VAN'S AIRCRAFT, INC.

Service Bulletin 08-6-1

Subject: F-1010 bulkhead reinforcement

Affected Models: RV-10

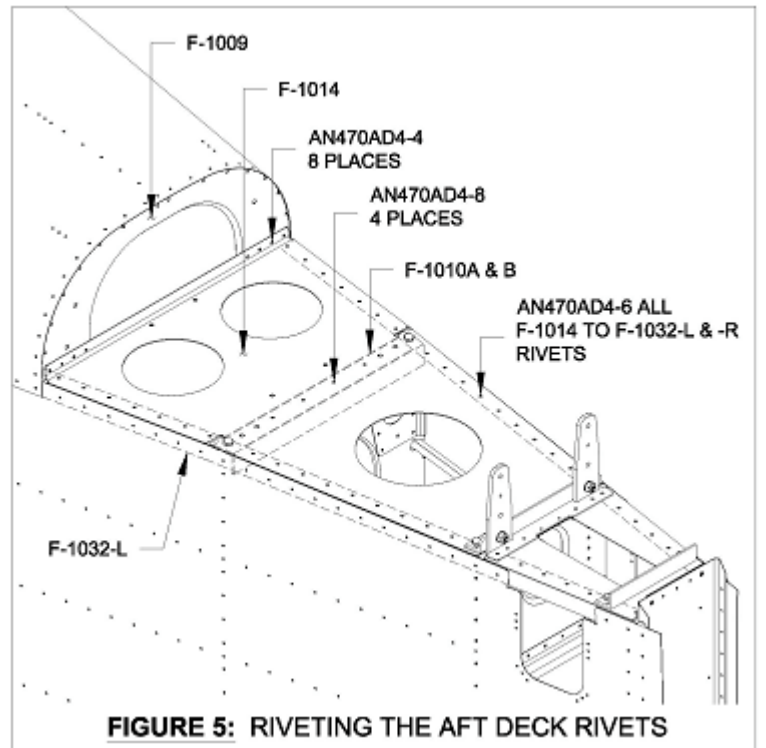
Crack in the upper left corner of F-1010 bulkhead....as seen from the back side looking forward.

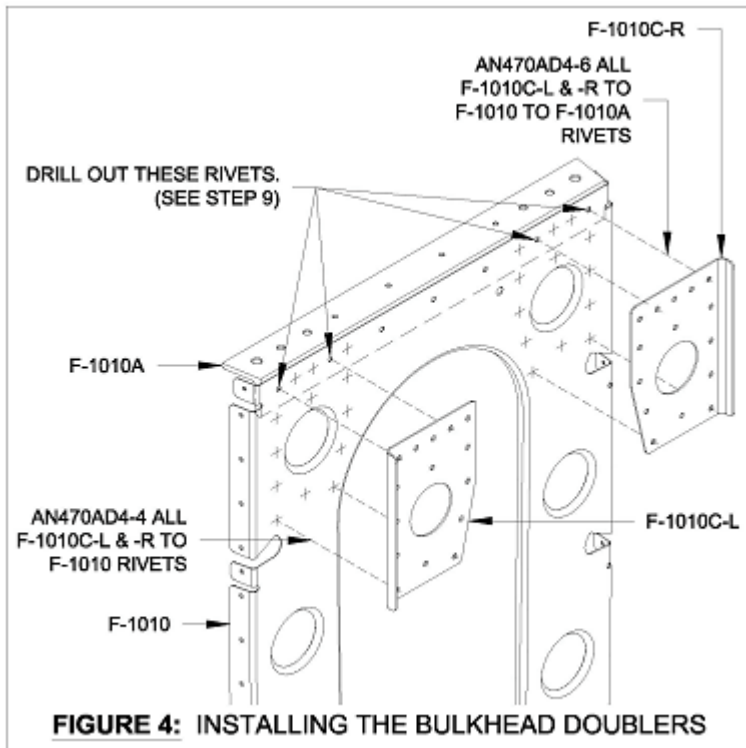
Crack in the upper left corner of F-1010 bulkhead....as seen from the front side looking aft.

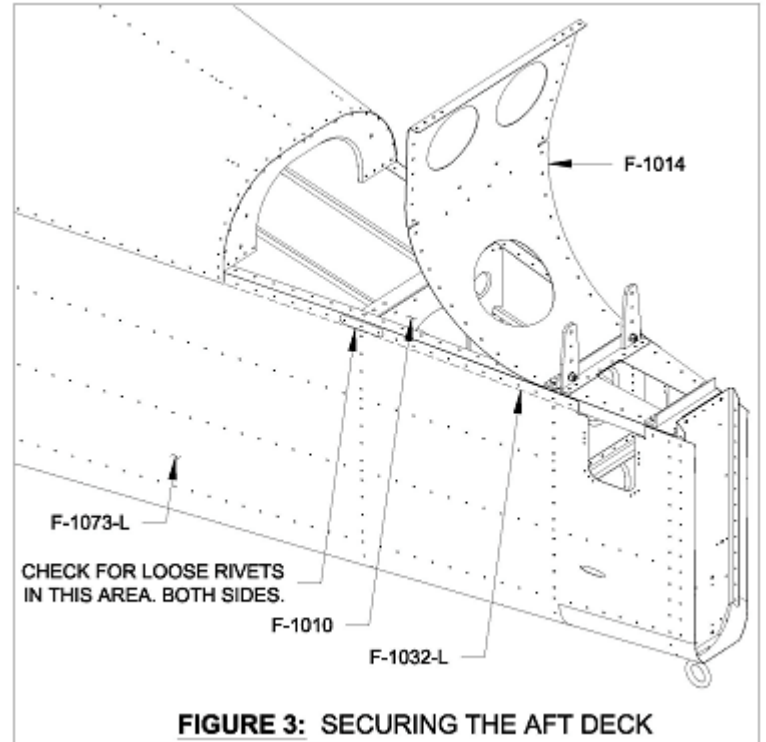
Empennage has been removed. The aft deck is held open and out of the way with this simple setup.

Step 7: As shown in Figure 3, pull back the F-1014 Aft Deck and secure it in position with a rope, wire, etc.

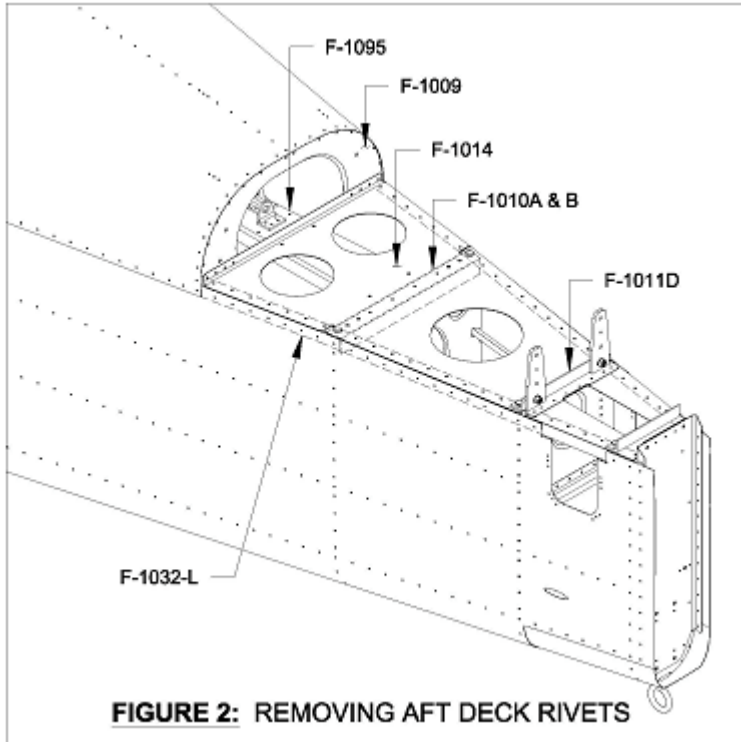
Doublers clecoed/clamped in place after match drilling.

F-1010C doubler riveted in place.

Step 11: Cleco the F-1010C-L & -R Bulkhead Doublers to the F-1010 Bulkhead and F-1010A Horizontal Stabilizer Attachment Angle using the holes for the rivets removed in Step 9. See Figure 4.

Step 14: Rivet the F-1010C-L & -R Bulkhead Doublers to the F-1010 Bulkhead and F-1010A Horizontal Stabilizer Attachment Angle using the rivets called out in Figure 4.

FIGURE 1: ELEVATOR TRIM CABLE

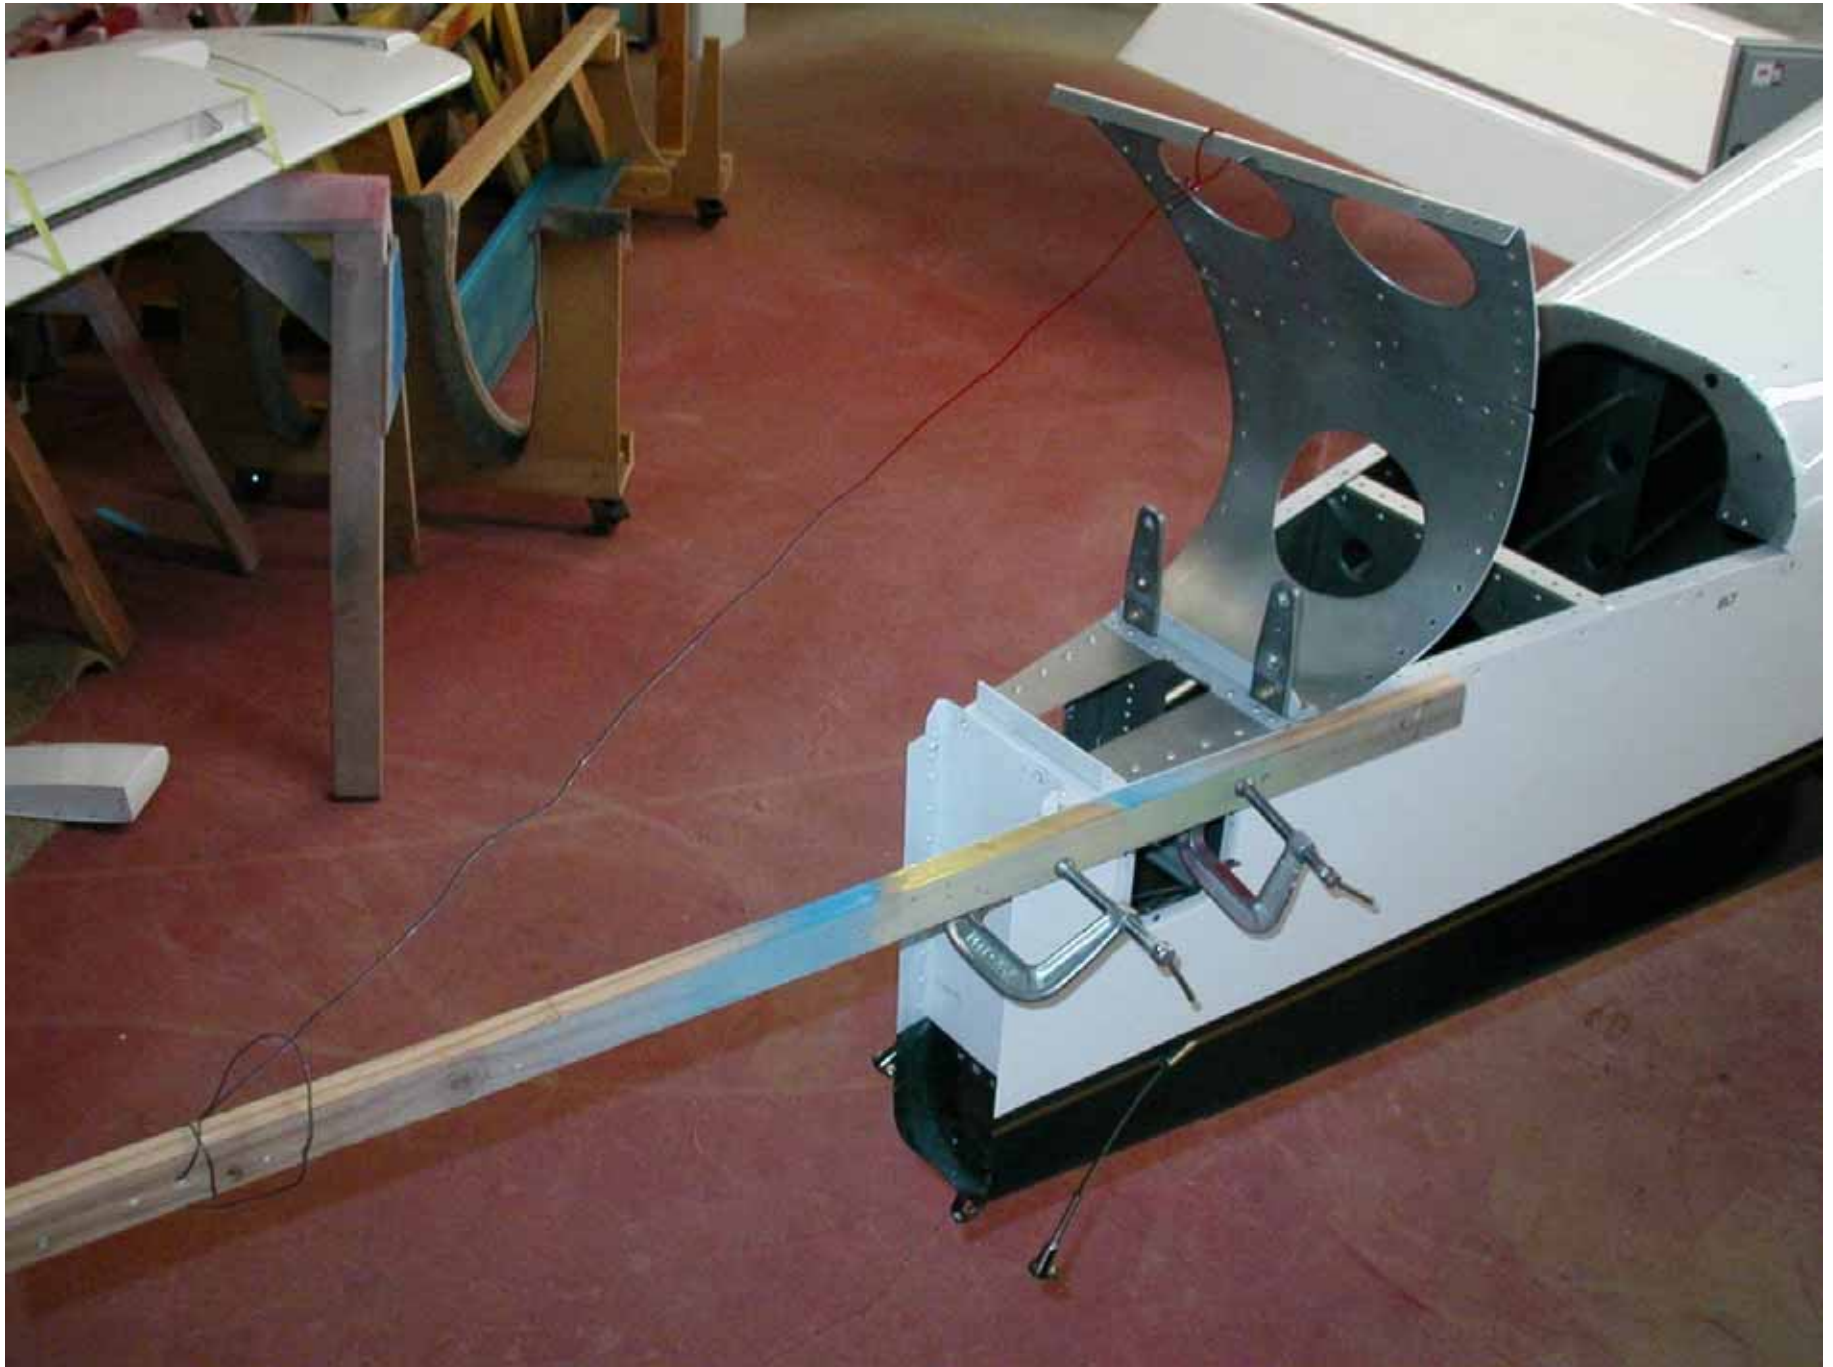
- a) Crawl inside the tailcone (lay boards across the tailcone frames) and remove the bolts and nuts securing the MW-3M Rod Ends to the F-1095B Trim Bellcrank. See Figure 1.
- b) Remove the MW-3M Rod Ends from the CT Q-43 Elevator Trim Cables. For later reassembly, note the number of turns each rod-end is unthreaded from the elevator trim cables. See Figure 1.
- c) Remove the forward anchor nuts from the CT Q-43 Elevator Trim Cables (leave the aft anchor nuts in place so the elevator trim cables can be reassembled in the same position), then pull the elevator trim cables through the F-1095G Trim Cable Anchor Brackets. See Figure 1.
- d) The entire horizontal stabilizer/elevator assembly can now be removed.
